MANN-FILTER

Product Information

No. 120
12.08.2015

Design improvement CUK 2940

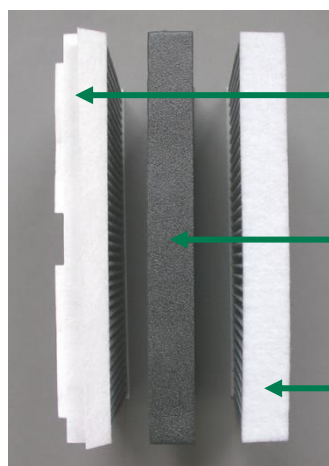
Because of a change in design in the OES, the MANN-FILTER cabin air filter CUK 2940 has also been adapted.

The new material of the frame at the longitudinal side still cares for an optimal sealing in the filter seat. This is whereby the original press cuts and the V-flap can be removed.
